**Re: PERCOLATION TEST RESULTS
Receipt # - A530998**

Percolation Certification Plan

Location Survey
 14565 Mustang Path
 Glenwood Estates subdivision

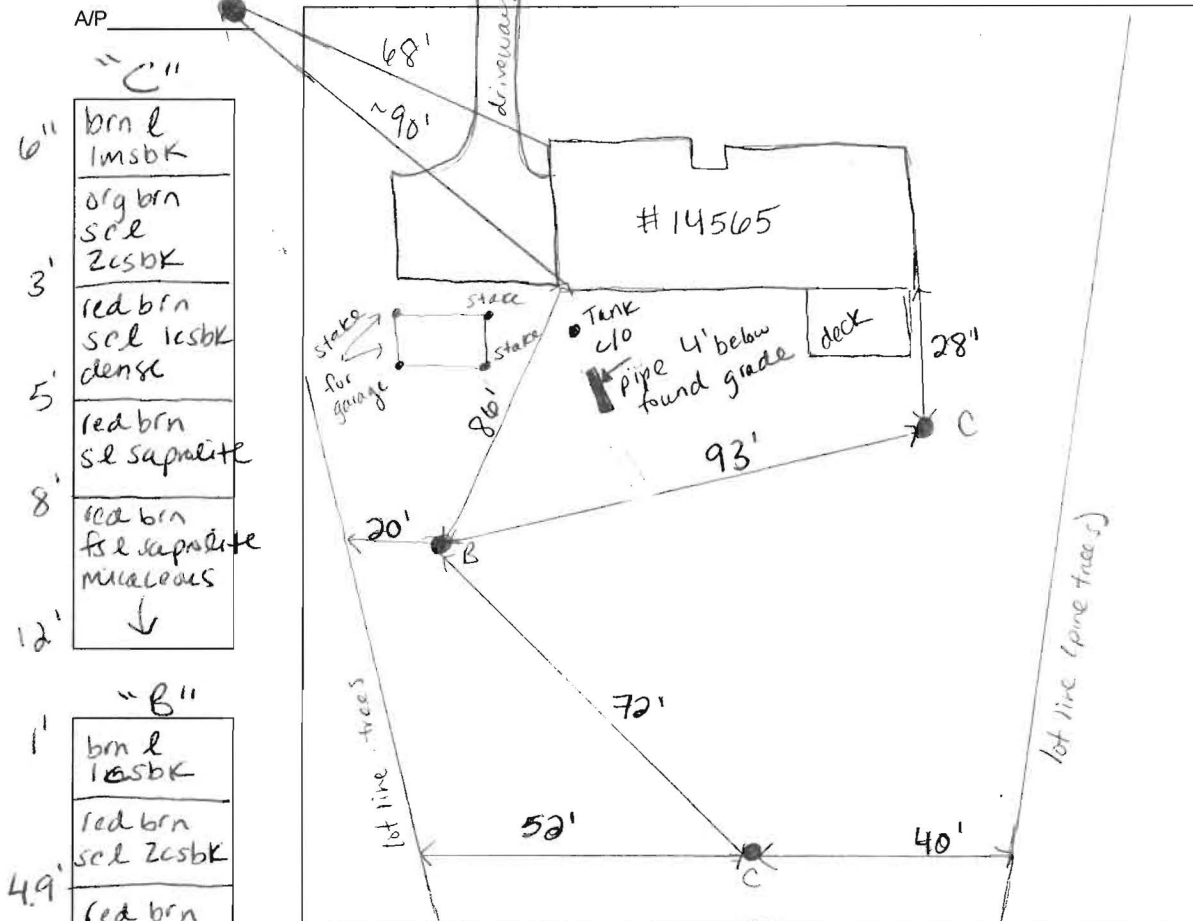
- 6" "C"
brn l
lmsbk
- 3' org brn
scl
Zcsbk
- 5' red brn
scl lcsbk
dense
- 8' red brn
scl saprolite
- 12' red brn
fs l saprolite
micaceous
↓
- 1' "B"
brn l
lcsbk
- 4.9' red brn
scl Zcsbk
- 7' red brn
scl saprolite
- 12.2' red/yellow
brn fs l
saprolite
common
mica
↓
- 8" "A"
brn l
lmsbk
- 4' red/org
brn scl
Zmsbk
- yellow &
red brn
scl
↓
- 8' fs l &
saprolite
(same as
B+C)
- 12'

DATE	TEST #	DEPTH	START	BREAK 1" DROP	STOP 2" DROP	TIME OF 2ND INCH	P/F/H
10-8-09	C	5.5' / 12'	9:29	9:44	10:09	25	P
6-8-09	B	6.5' / 12'	9:48	9:59	10:10	17	P
6-8-09	A	5.6' / 12'	10:11	10:28	10:53	25	P

REMARKS well ~15' from lot line
located trenches per as built, found pipe from tank to d-box

TEST HOLES USED IN SDA 3 AVG. PERC TIME 22 SQ. FT/BR _____

TRENCH WIDTH 2' INLET DEPTH 4 MAX. BOT DEPTH 8' EFFECTIVE SW 1.5'-2'

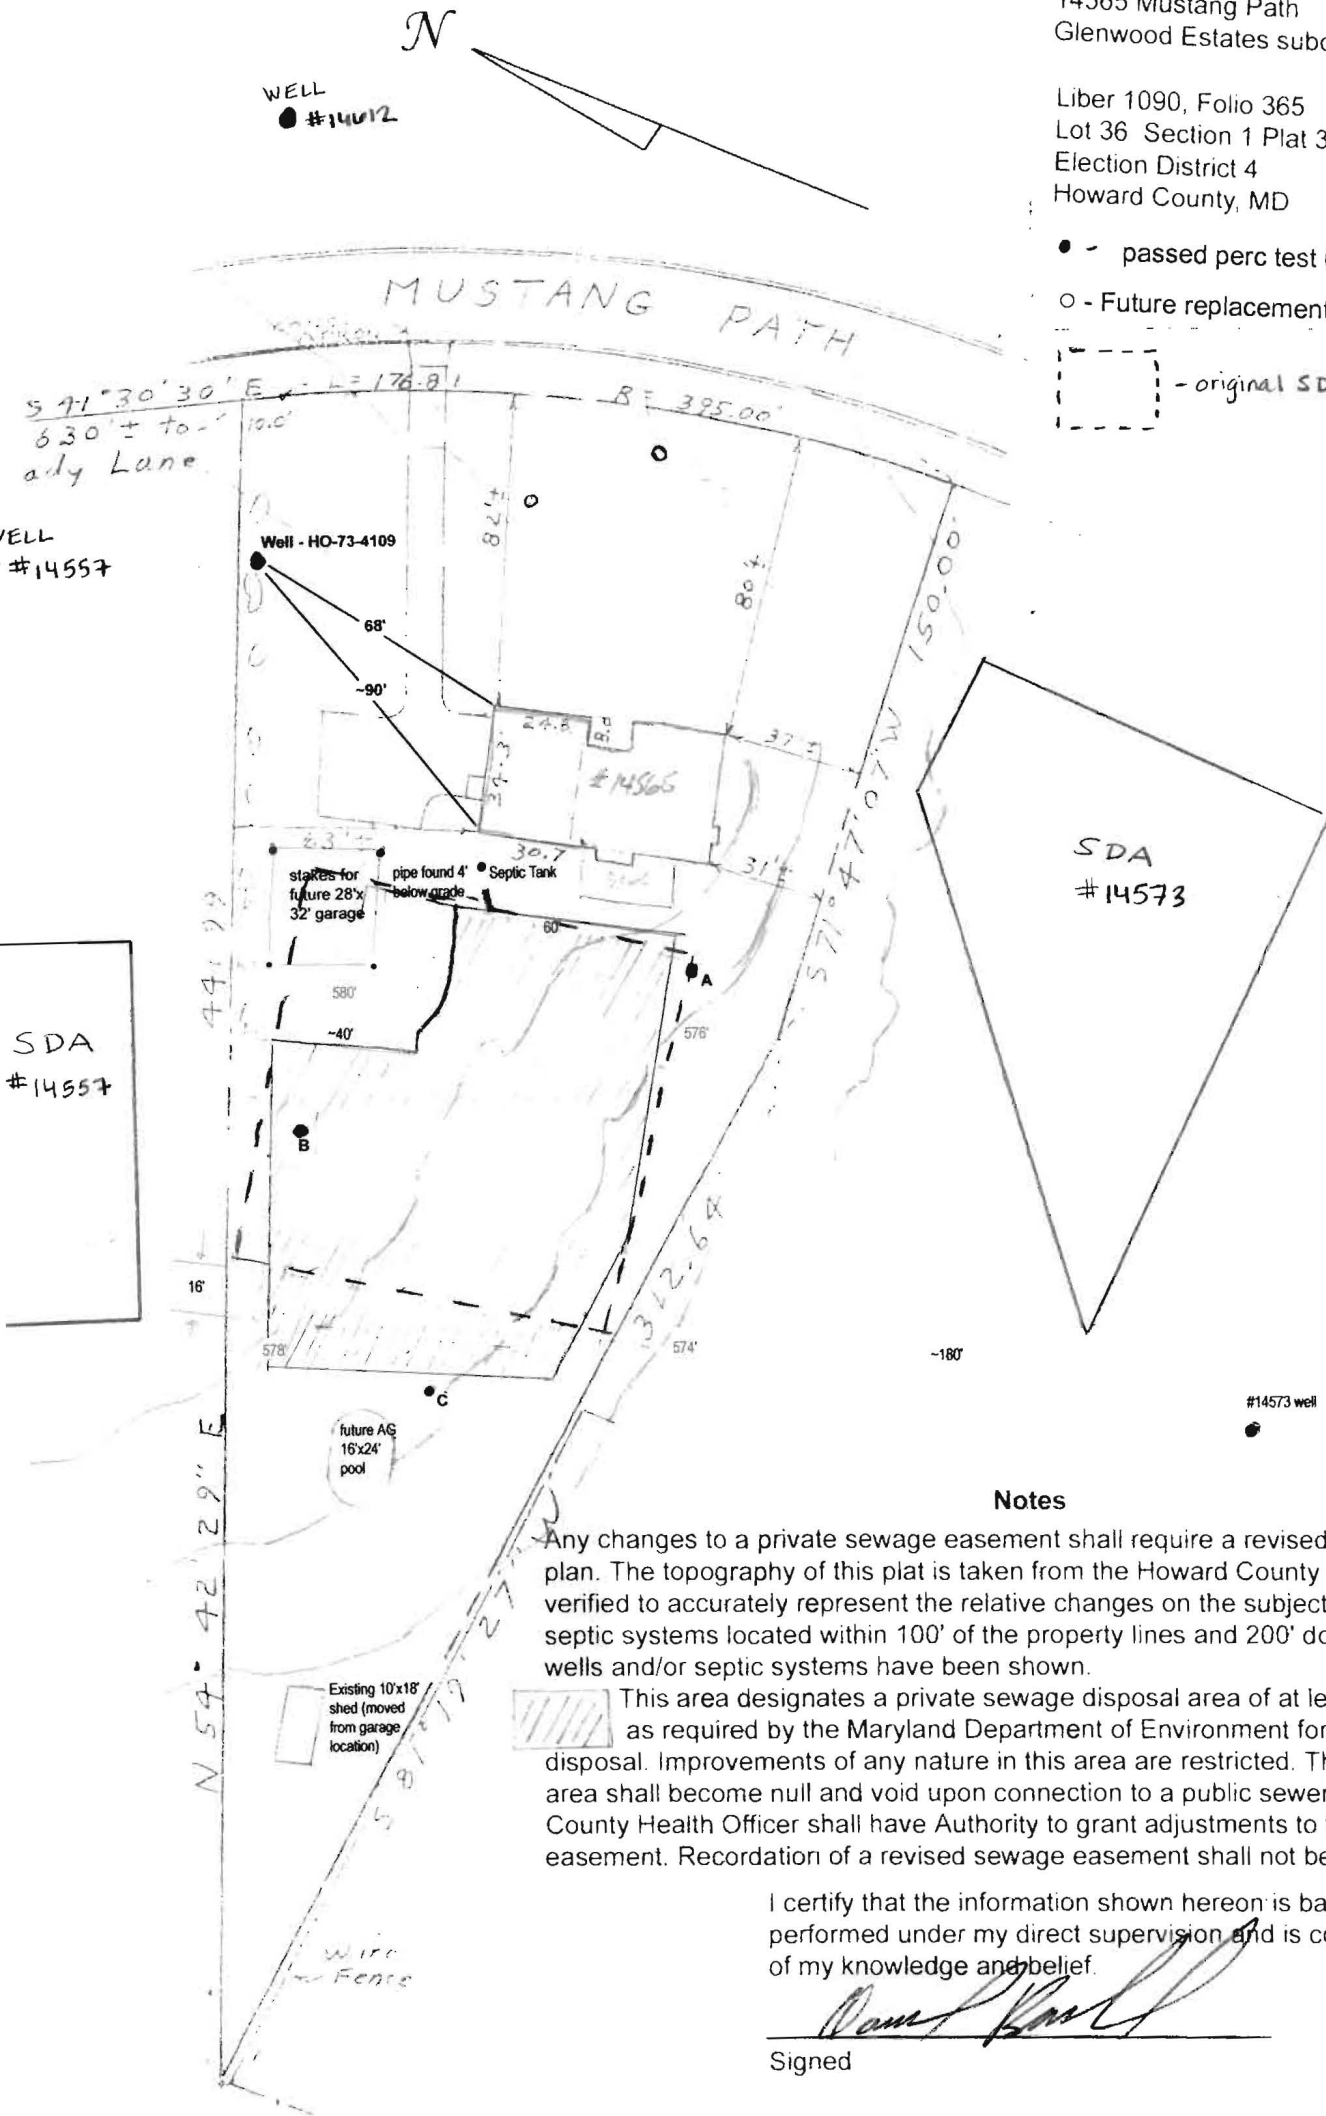
Percolation testing was conducted at your property on June 8th, 2009 in response to a proposed garage and aboveground pool which require revision to the existing septic easement on your lot. Results indicate satisfactory soil conditions for onsite wastewater disposal. A total of 3 test holes were dug to confirm existing conditions. Uniform soils consisting of fine sandy loams and saporlites were identified in all test holes. All test holes had passing perc rates. Field data collected is shown on the Percolation Test Worksheets enclosed with this letter. Acceptable ranges for recommended inlet and trench bottom depth, and usable sidewall have been provided, and may be confirmed at the time of installation.

During an attempt to locate the existing trenches the pipe from the septic tank to the distribution was exposed. The distance to the proposed garage and existing trenches must be at least 20 feet. It was confirmed that the trenches are greater than the required distance given where the outlet pipe from the septic tank was located.

As discussed previously with Sara Sappington, since your existing septic system and easement is within 200 feet uphill of the neighboring well located at 14573 Mustang Path this well was tested for the presence of bacteria. Results of this test came back negative. Therefore, the Health Dept. will not require you to add a pretreatment unit for your septic tank.

Further review of this project is contingent upon submission of a Percolation Certification Plan. I have enclosed the plan requirements and some additional materials to assist you in preparing this plan. The Percolation Certification Plan must be approved prior to building permit approval

"Approved for Private Water and Private Sewer Systems"
B. W. Dwyer for Peter Beilensen
 Health Officer, Howard County Health Dept. *HS* 8/12/2009
 Date
